PROPOSED CHANGES TO THE  
COOK NUCLEAR PLANT UNIT NO. 1  
TECHNICAL SPECIFICATIONS

PROPOSED CHANGES TO THE  
COOK NUCLEAR PLANT UNIT NO. 2  
TECHNICAL SPECIFICATIONS

CURRENT PAGES MARKED-UP TO REFLECT PROPOSED CHANGES TO THE  
COOK NUCLEAR PLANT UNIT NO. 1  
TECHNICAL SPECIFICATIONS

CURRENT PAGES MARKED-UP TO REFLECT PROPOSED CHANGES TO THE  
COOK NUCLEAR PLANT UNIT NO. 2  
TECHNICAL SPECIFICATIONS

Figure 2.1-1

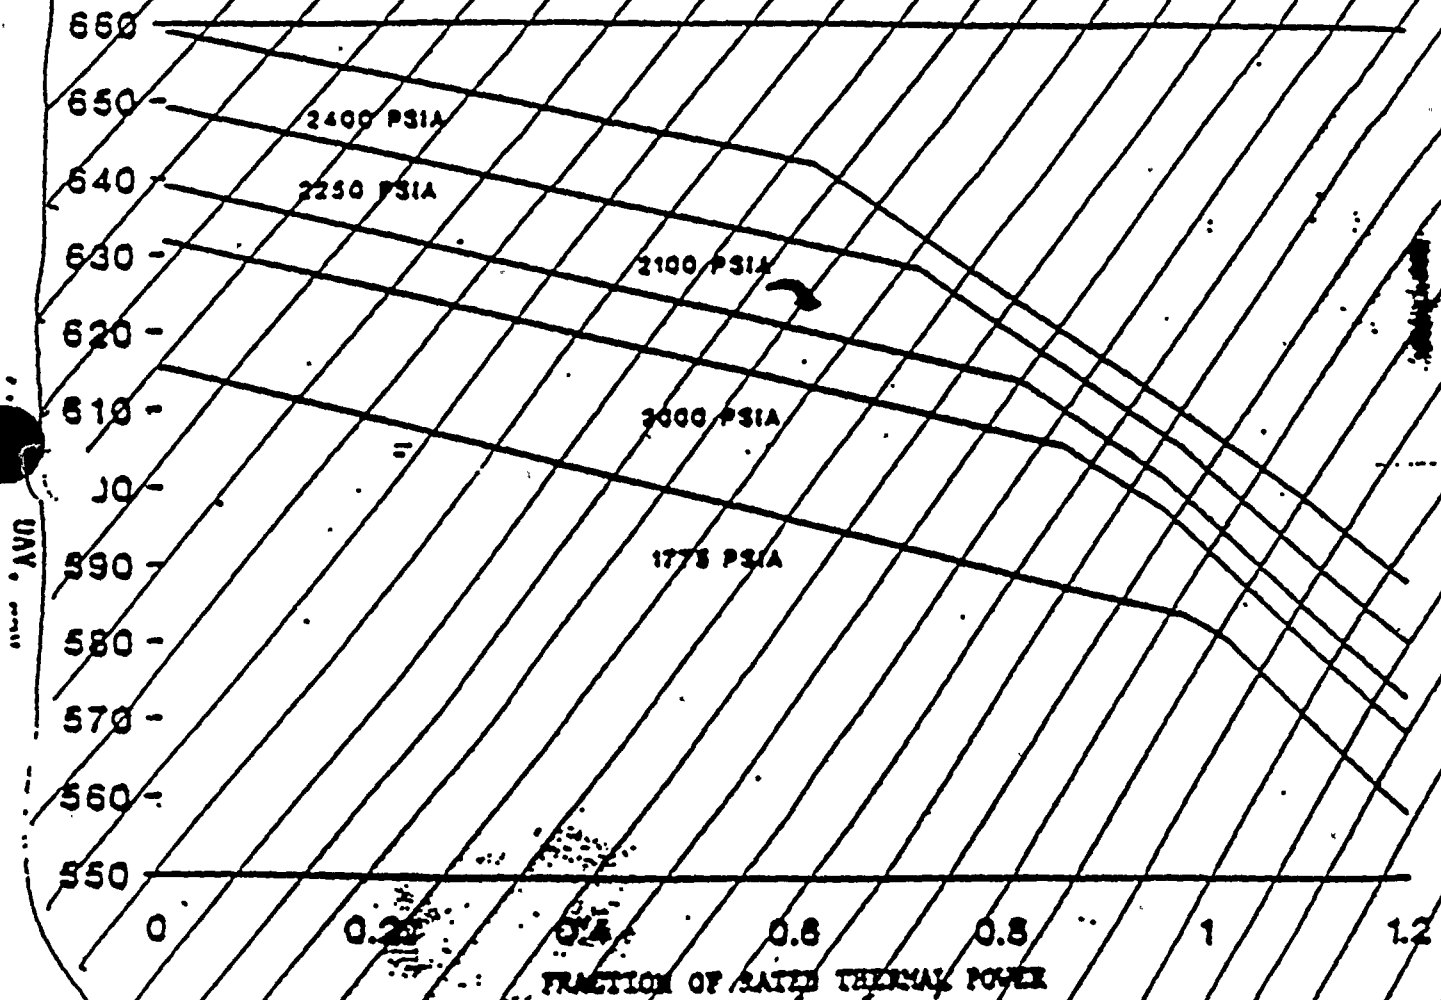
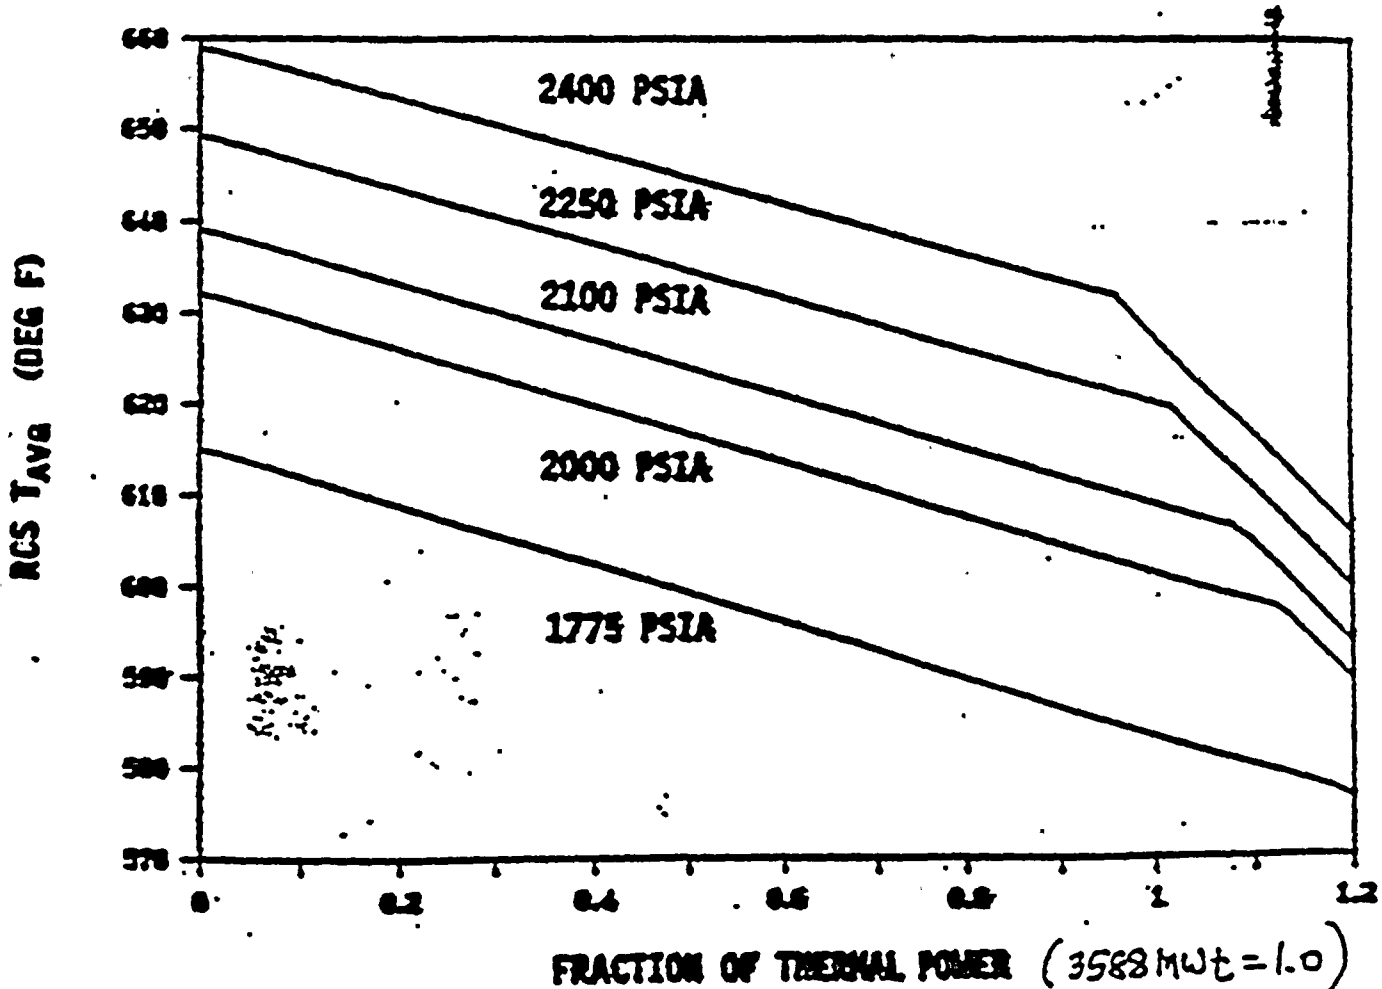
Delete, use next page

2-2	Figure 2.1-1	Margin	Revise Reactor Core Safety Limits	<p>The Safety Limit Figure currently in the Unit 2 Technical Specifications was designed for a mixed core of Westinghouse and Advanced Nuclear Fuel. The Unit 2 core now consists totally of Westinghouse Vantage 5 fuel. The new thermal design is discussed in Section 3.3.2.1 of Attachment 6 WCAP 14489. The proposed Safety Limit Figure is consistent with a rated thermal power of 3588 MWt and an all Vantage 5 core.</p>

FIGURE 3.4-2

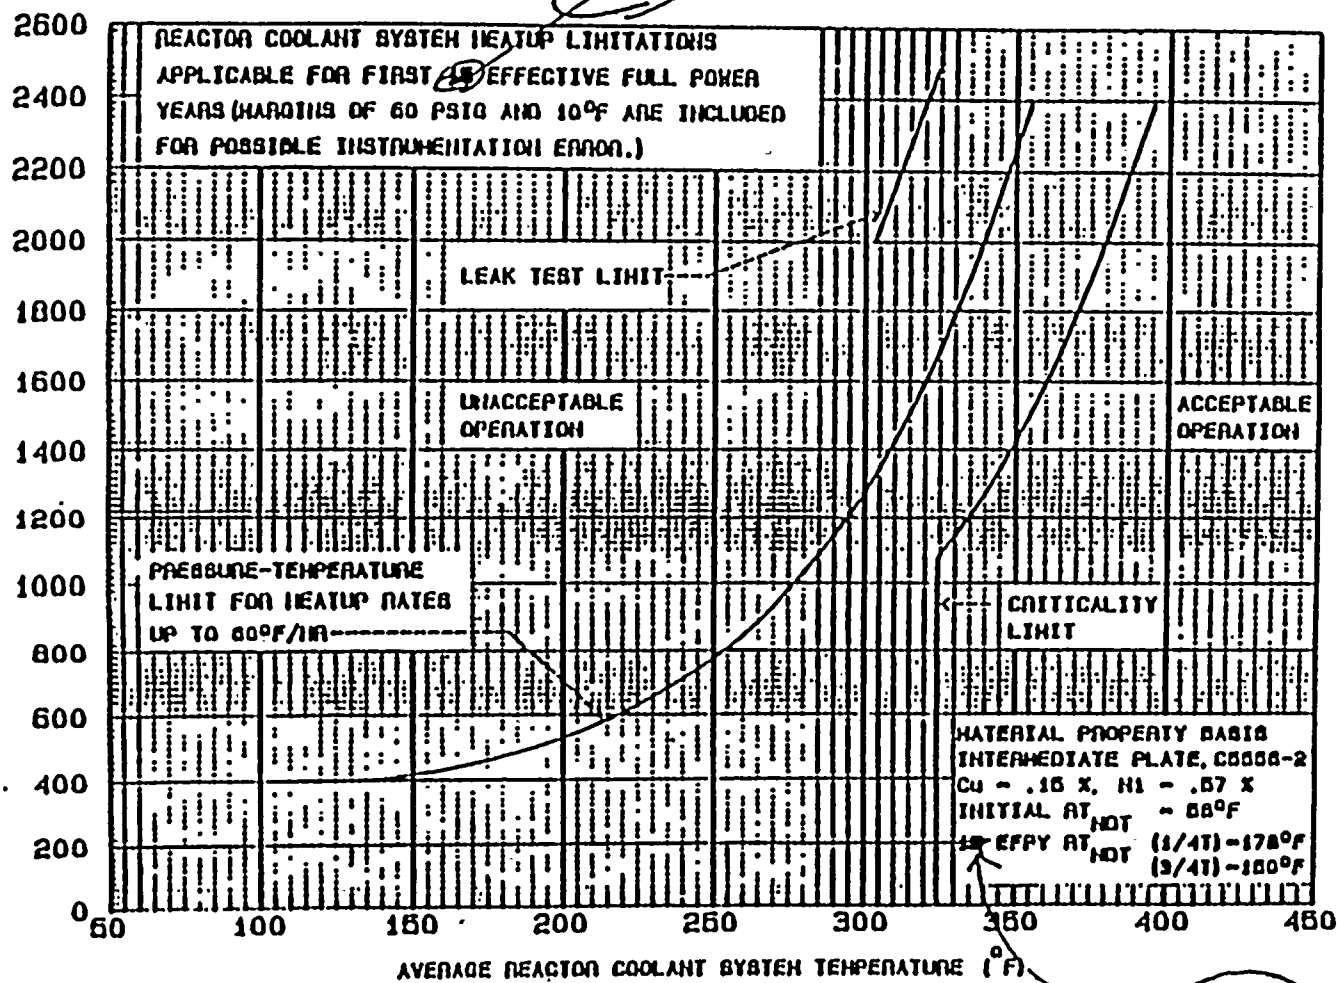
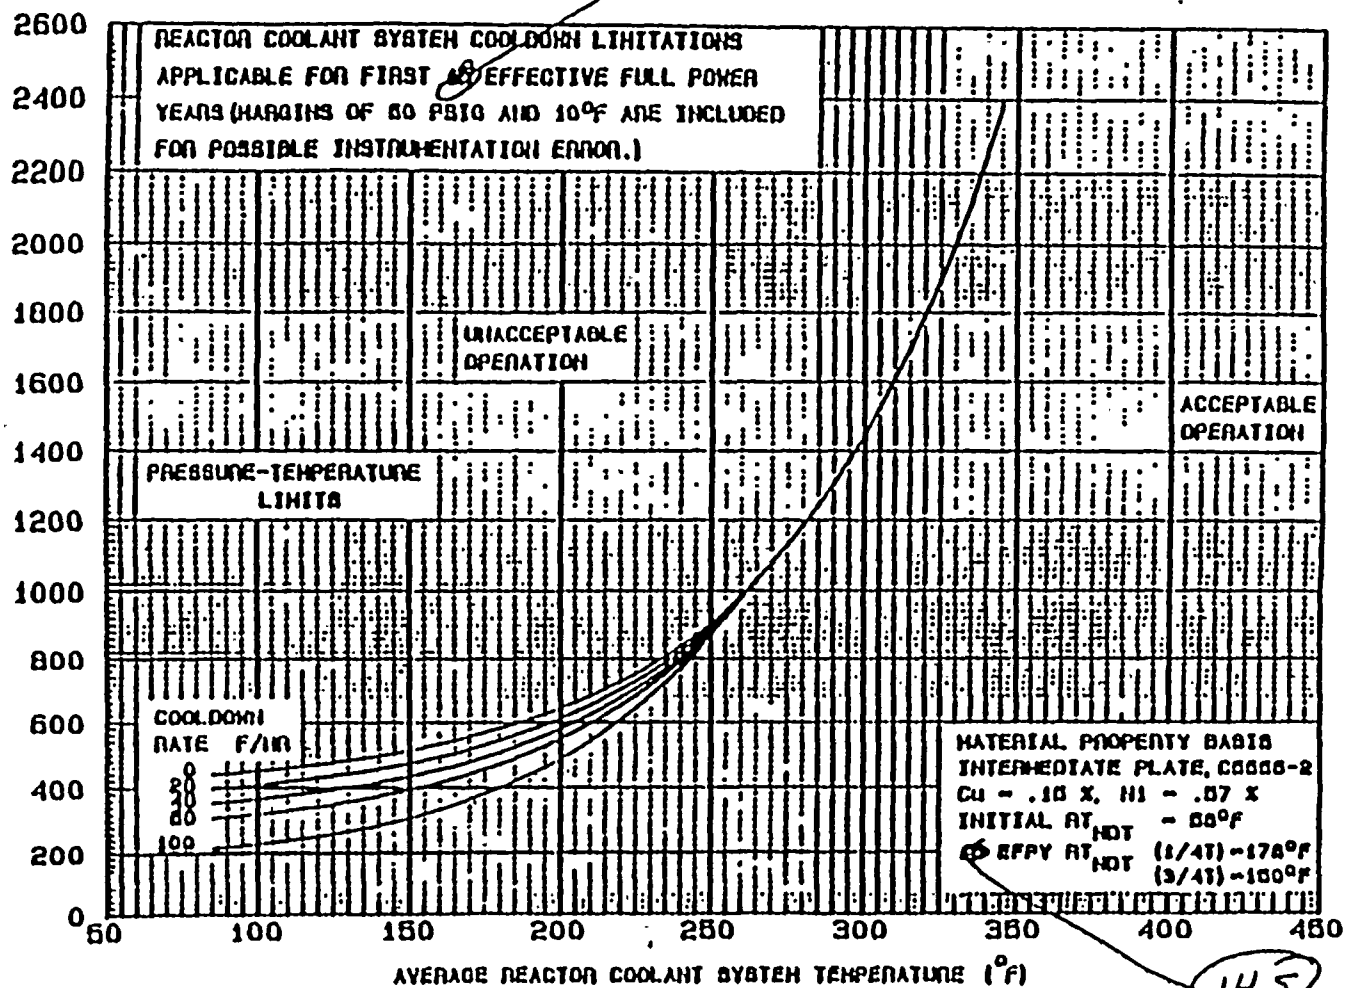
Page	Section	Group	Description	Remarks
3/4 4-16	Section 4.4.6.2.1	Transition	Pressure criteria for both analyzed nominal RCS pressures are indicated.	Due to the analysis performed for transition cores of both Westinghouse and Advanced Nuclear Fuel, low pressure operation was not permitted for operation with mixed cores of Westinghouse and Advanced Nuclear Fuel. The basis for this limitation is discussed in Section "Group 4" of Attachment 1. Unit 2 is currently operated with cores of all Westinghouse Vantage 5 fuel. Therefore, low pressure operation is acceptable.
3/4 4-25	Figure 3.4-2	Uprate	Reduce the applicability of the heatup curve from 15 to 14.5 EFPY's.	The applicability of the current heatup and cooldown curves is discussed in Section 3.11.2.1 of Attachment 6, WCAP 14489.
3/4 4-26	Figure 3.4-3	Uprate	Reduce the applicability of the cooldown curve from 15 to 14.5 EFPY's.	See the remark on the applicability of the heatup and cooldown curves on page 3/4 4-25

B3/4 2-4a	Bases Section 3/4.2.2 and 3/4.2.3	Transit ion	Remove references to Advanced Nuclear Fuel.	The Unit 2 core now consists totally of Westinghouse Vantage 5 fuel.
B 3/4 2-5	Bases Section 3/4.2.5	Transit ion	Remove reference to low temperature limit in order to return the specification to a purely DNB specification.	See remark on low temperature limit on page 3/4 2-15.
B 3/4 4-6	Bases Section 3/4.4.9	Uprate	Reduce the applicability of the heatup and cooldown curves from 15 to 14.5 EFPY's.	See remark on the applicability of the heatup curve on page 3/4 4-25.
B 3/4 4-10	Bases Section 3/4.4.9	Uprate	Reduce the applicability of the heatup and cooldown curves from 15 to 14.5 EFPY's.	See remark on the applicability of the heatup curve on page 3/4 4-25.

Figure 2.1-1

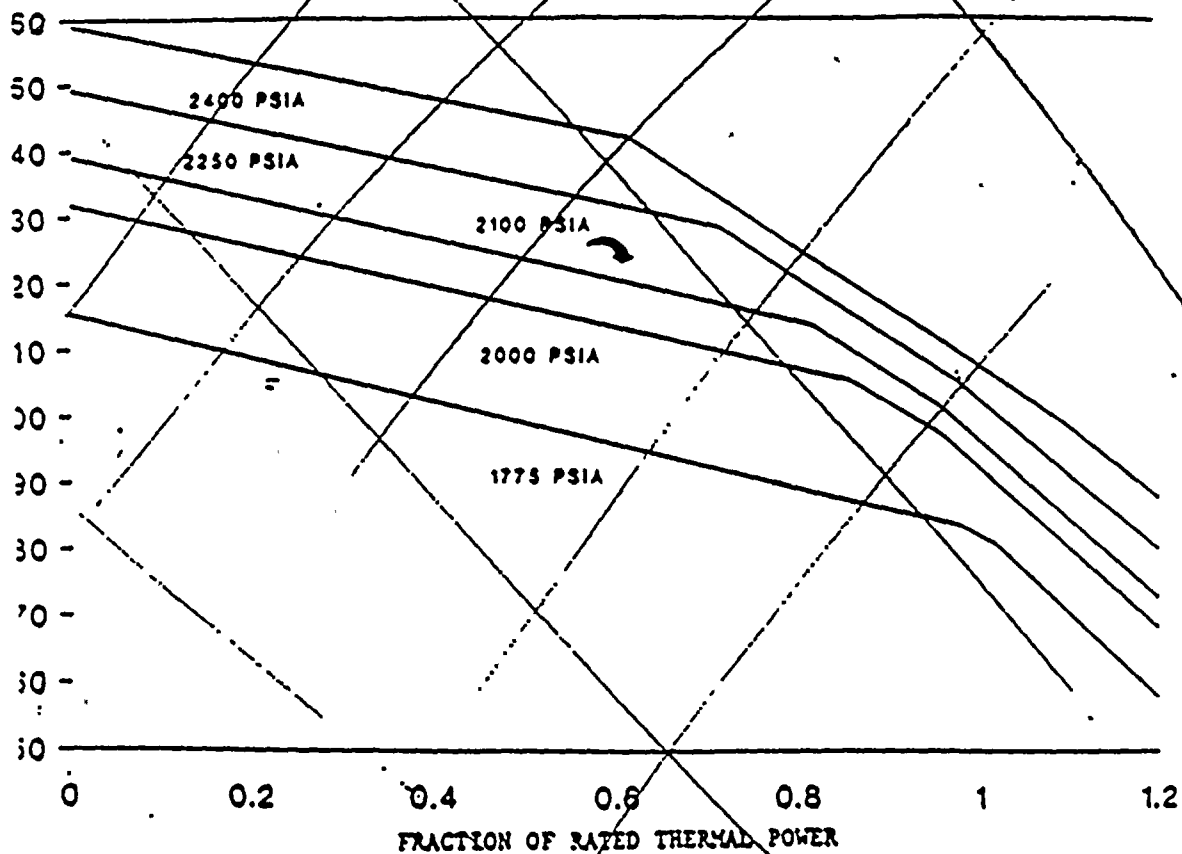
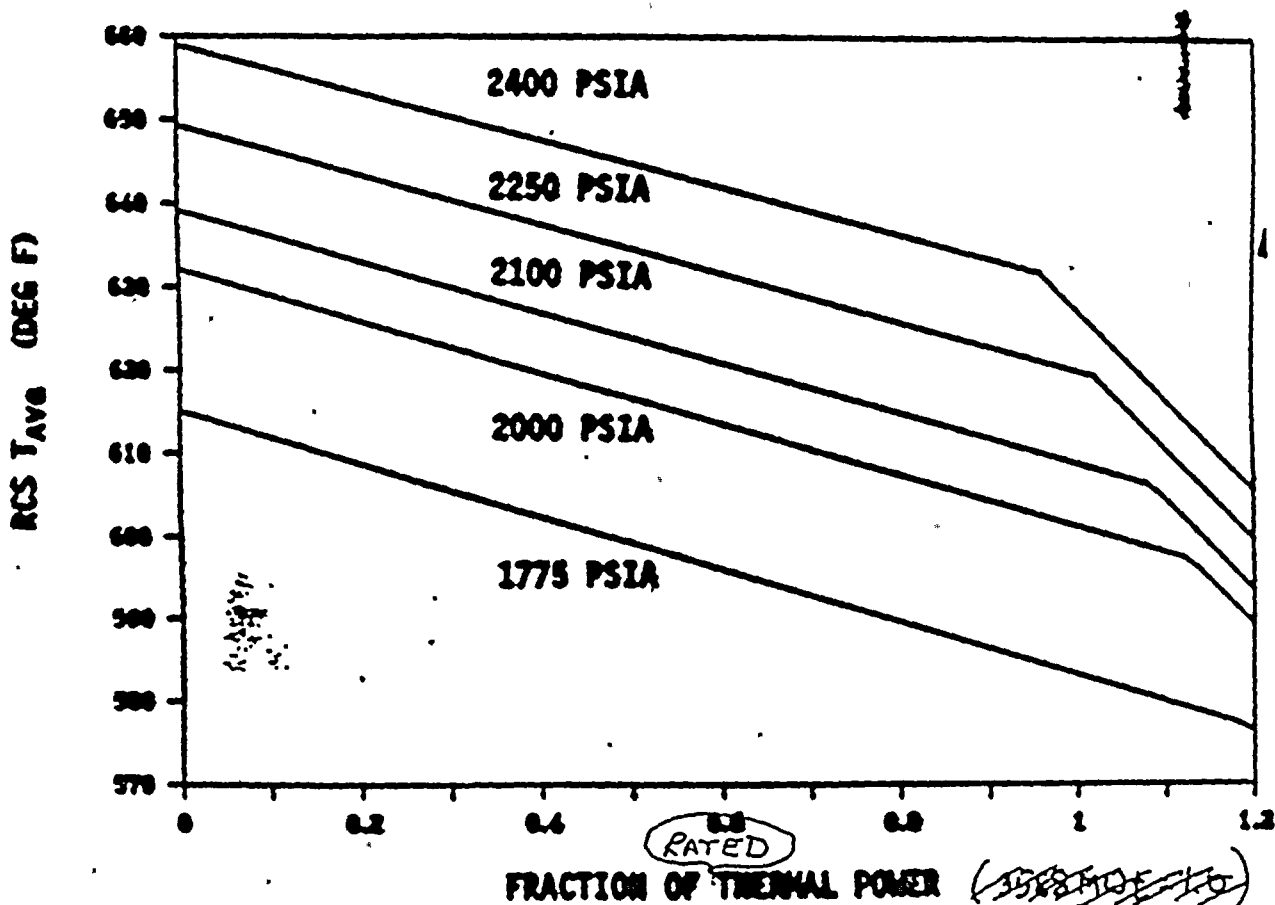
*Revised with Inert 2.1-1*

FIGURE 3.4-2

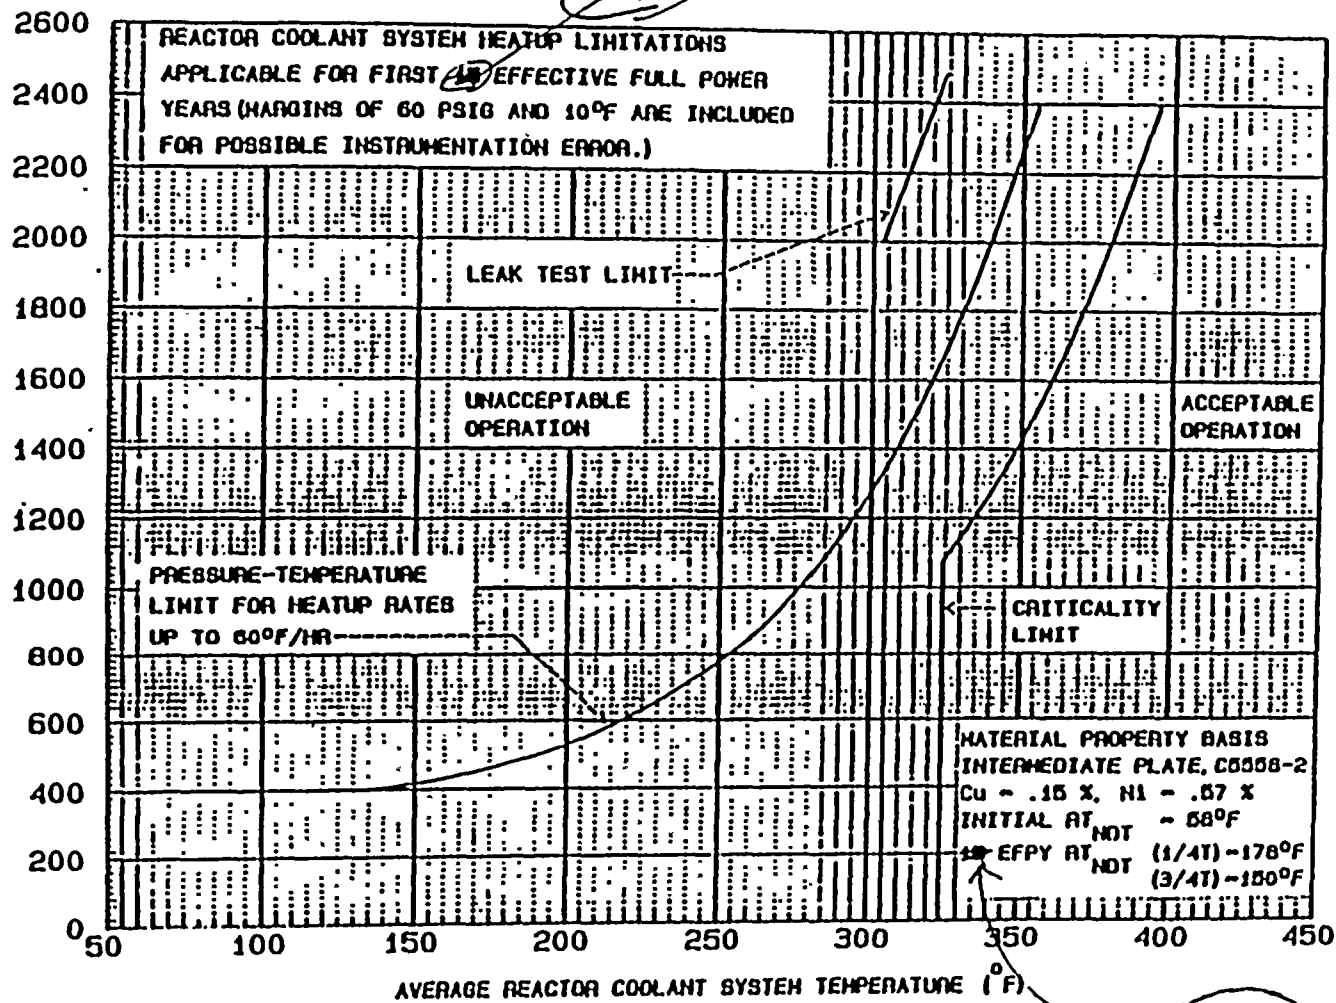
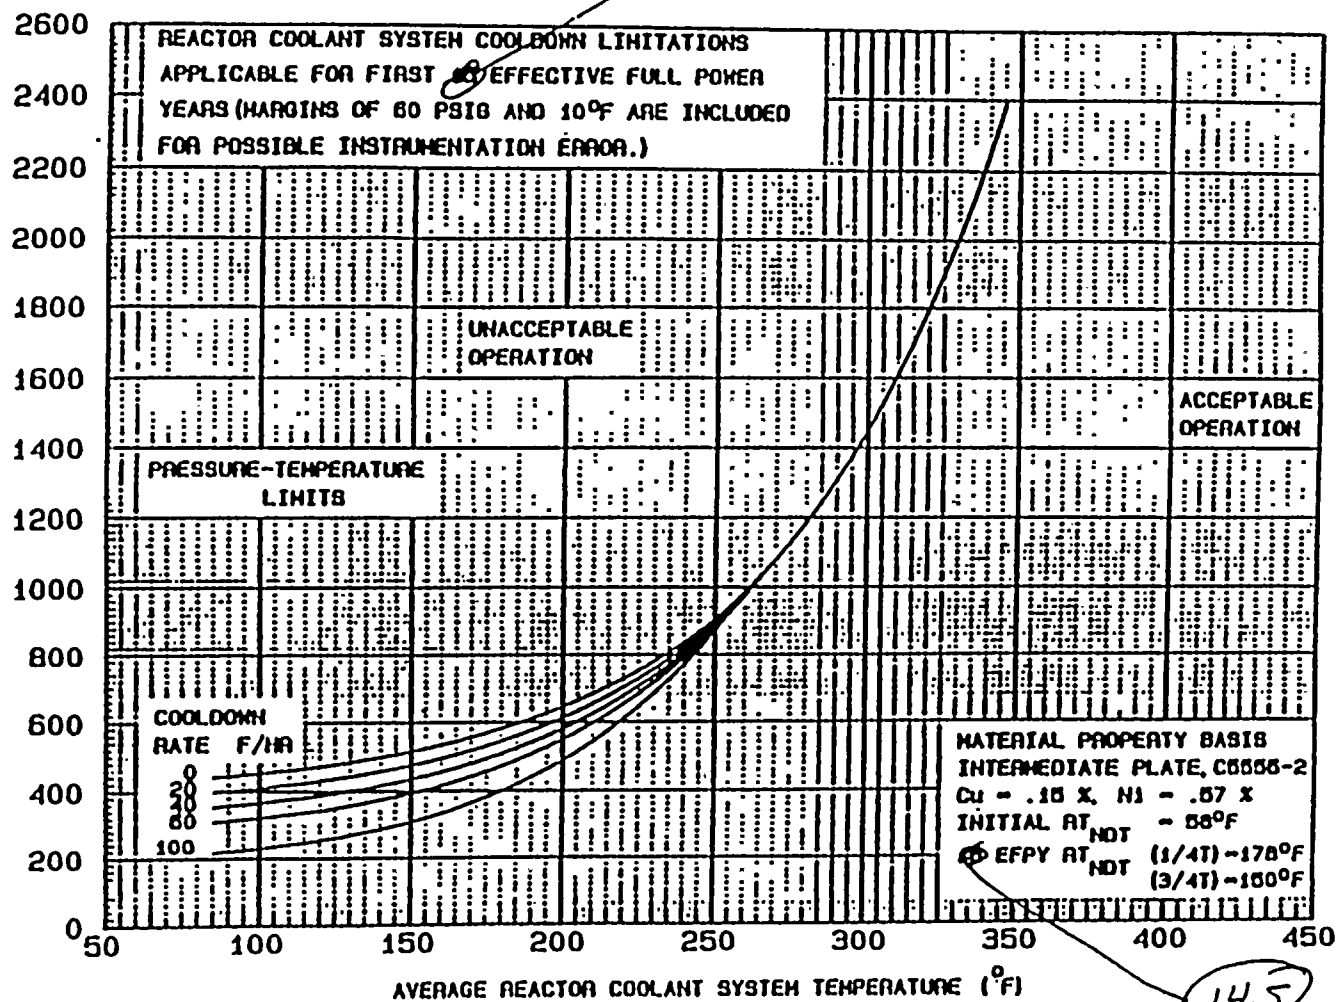
The heatup limit curve, Figure 3.4.2, is a composite curve which was prepared by determining the most conservative case, with either the inside or outside wall controlling, for any heatup rate up to 60°F per hour. The cooldown limit curves of Figure 3.4-3 are composite curves which were prepared based upon the same type analysis with the exception that the controlling location is always the inside wall where the cooldown thermal gradients tend to produce tensile stresses while producing compressive stresses at the outside wall. The heatup and cooldown curves were prepared based on the most limiting value of the predicted adjusted reference temperature at the end of ~~30~~ <sup>14.5</sup> KFFX.
